Date: 9th September 2015
To: Gerry Geoghegan
Ref: 150909WSP1_Lough Derg AA Screening Update_A01
Re: Review of AA screening outcome in light of revised instrument location

The Water and Hydrographic Sampling Programs (Lough Derg) - Appropriate Assessment Screening Statement (150126WSP1_LoughDergAAScreening) ('The Screening Report') concluded that the proposed water quality and hydrographic sampling programs are not likely to have a significant effect on any European sites, either alone or in combination with other plans or projects.

Figure 2: Revised Horizontal ADCP configuration and location

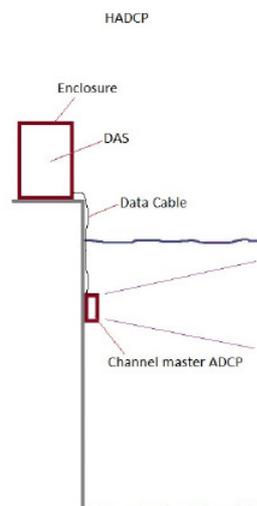
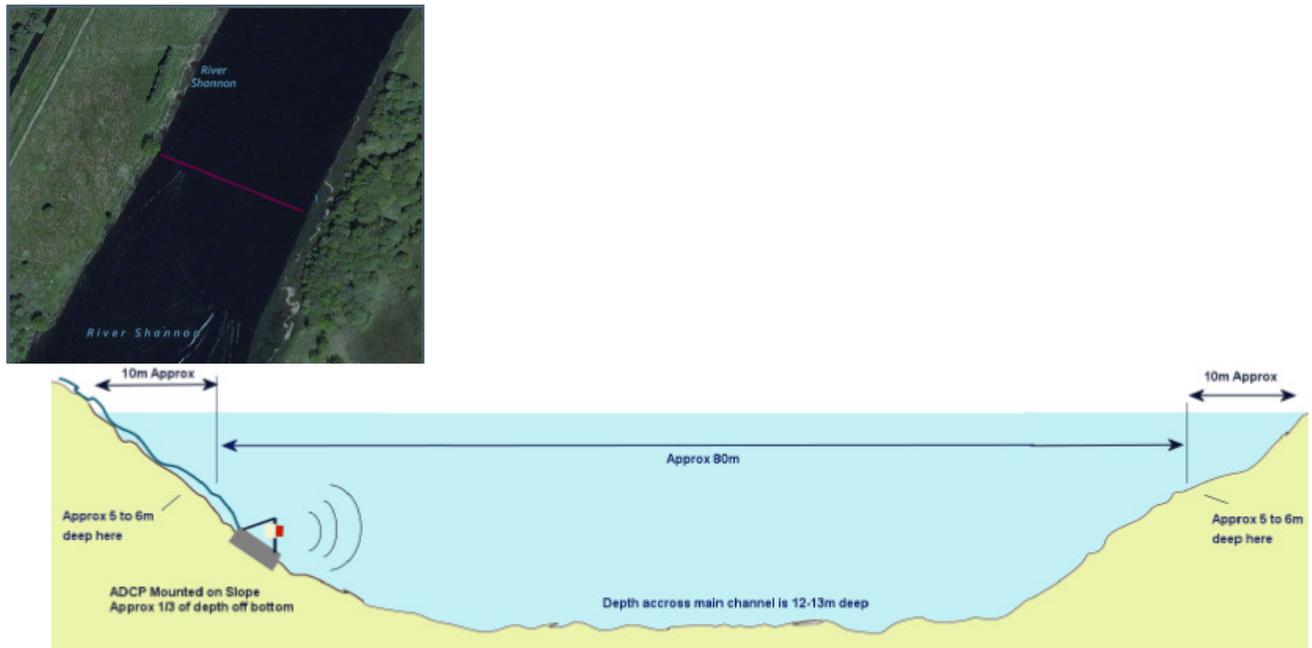
This location has since been revised to a frame-mounted bank side location downstream of Portumna Bridge (Figure 2)

The frame will consist primarily of two steel poles driven to refusal from a floating barge, to which a supporting structure will be attached, and upon which the ADCP will be mounted. The ADCP will be installed at approximately 35% of water depth at this location. The installation will be removed at survey completion.

No new source-pathway-receptor links will arise between the proposed survey programme and the Qualifying Interests of any European sites, as a result of the amended ADCP location and installation methodology. The revised ADCP location is within the Lough Derg North East Shore cSAC and Lough Derg (Shannon) SPA. However, there is no potential for Qualifying Interest habitats of any European sites to occur within the footprint of the works. There is no potential for the temporary localised disturbance associated with the installation or servicing of the ADCP to significantly affect mobile species including birds. The Screening Report ruled out the potential for underwater noise from ADCP operation to affect mobile fauna as the operating frequency does not overlap with the auditory bandwidth of any QI species. A highly precautionary approach was adopted when assessing the potential for silt to affect the highly sensitive freshwater pearl mussel populations within the Lower River Shannon cSAC downstream. However the zone of influence for potential siltation effects associated with the disturbance of the river bed will be limited to the scale of sub-catchment or hydrometric area scale (i.e. silt mobilised from the disturbance will not settle out beyond this boundary) and there are no designated freshwater pearl mussel populations within hydrometric area 25 within which the works will be located.

Figure 5: Killmastulla Met Mast structure

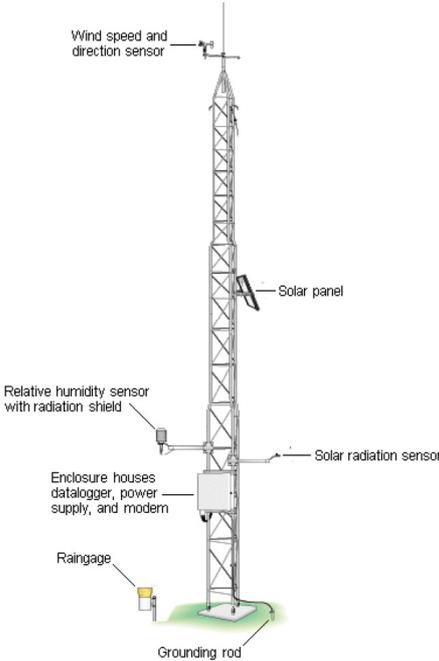
The Meteorological station will be a lattice tower that will stand approximately 15m high, installed using pre-cast block on amenity grassland beside the pump house access area. Its location is immediately adjacent to the ESB embankments at this location, of existing height circa 9m from ground level.

No new source-pathway-receptor links will arise between the proposed survey programme and the Qualifying Interests of any European sites, as a result of the amended met mast locations and installation methodologies.

There is no potential for Qualifying Interest habitats of any European sites to occur within the footprint of either works. There is no potential for the temporary localised disturbance associated with either installation to significantly affect mobile species such as otter, as there will be no need to break ground at Kilmastulla (use of pre-cast concrete blocks) or Boula (affixed to existing structure). There is no significant strike risk to designated bird populations because neither structure is located near significant breeding areas for cormorant (e.g. Goat, Silver, or Rabbit islands on the north shores of Lough Derg). Any negligible strike risk to wandering birds away from core areas is further reduced by the 'collocation' of both vertical structures beside/on existing buildings which will increase the visibility of the masts to flying birds.
